Blackford Energy Park BESS – Planning Representation: Noise Assessment Review

1. Introduction

This representation relates to the operational noise impacts of the proposed Blackford Energy Park Battery Energy Storage System (BESS). It is based on a review of the applicant's original and revised Noise Impact Assessments, together with an independent professional acoustic review commissioned by local residents.

Appendix 1

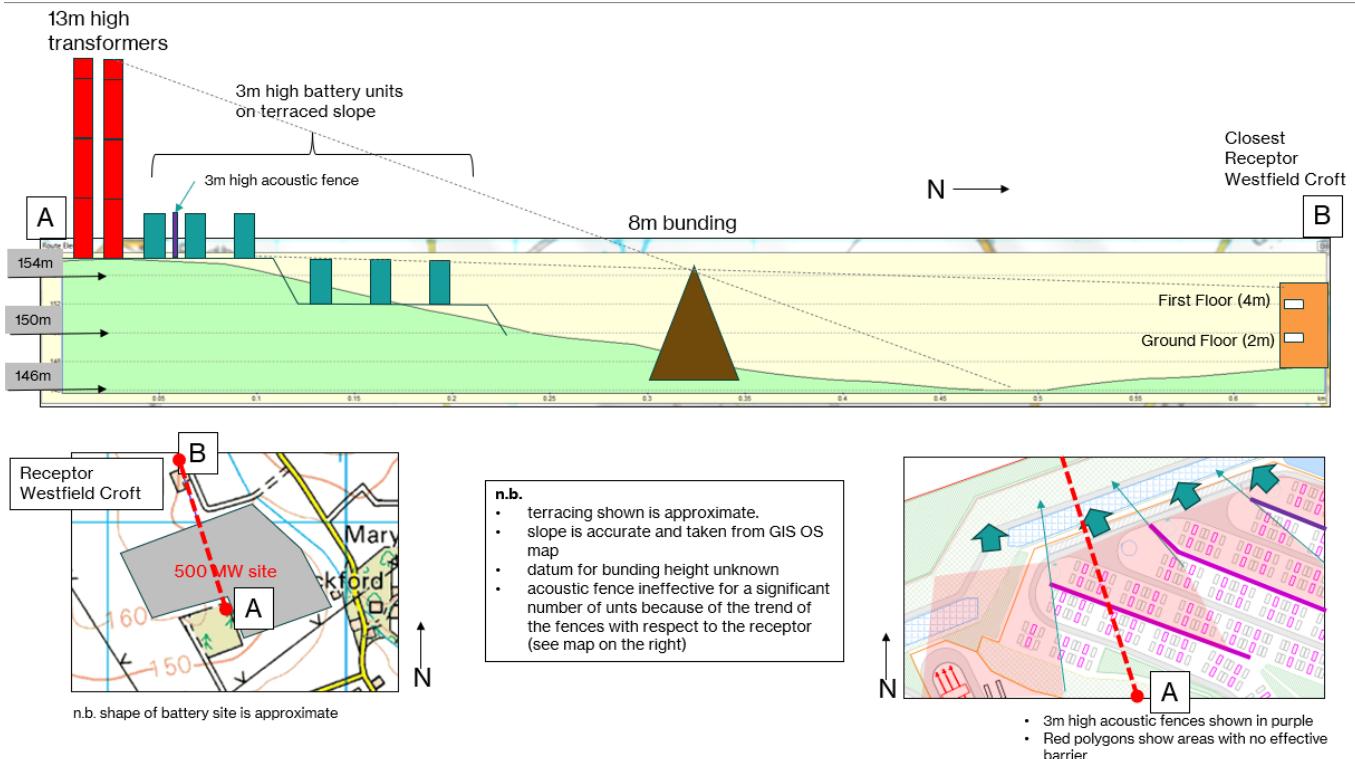
An illustrative **site–receptor cross-section (Appendix 1)** highlights why effective screening cannot be assumed for elevated plant and receptors, and why this should have been explicitly demonstrated in the noise assessment.

The geometric implications of this arrangement are illustrated in **Appendix 1**, which shows that for elevated plant on terraced ground, boundary mitigation of the scale proposed does not reliably break line-of-sight to elevated receptors. As a result, the specific sound level used in the BS 4142 assessment cannot be assumed to be representative of the sound likely to occur.

Appendix 1 provides an illustrative site–receptor cross-section prepared using conservative assumptions for plant height, boundary mitigation, and receptor height. While illustrative and not an acoustic model, it demonstrates the type of geometric relationship that the noise assessment itself should have presented and highlights why effective screening—particularly to first-floor receptors—cannot be assumed without explicit evidence.

Appendix 1 provides an illustrative site–receptor cross-section (slope is accurate and extracted from an OS map) using conservative assumptions for plant height, boundary mitigation, and receptor height. While illustrative and not an acoustic model, it demonstrates the type of geometric relationship that the noise assessment itself should have presented and highlights why effective screening—particularly to first-floor receptors—cannot be assumed without explicit evidence.
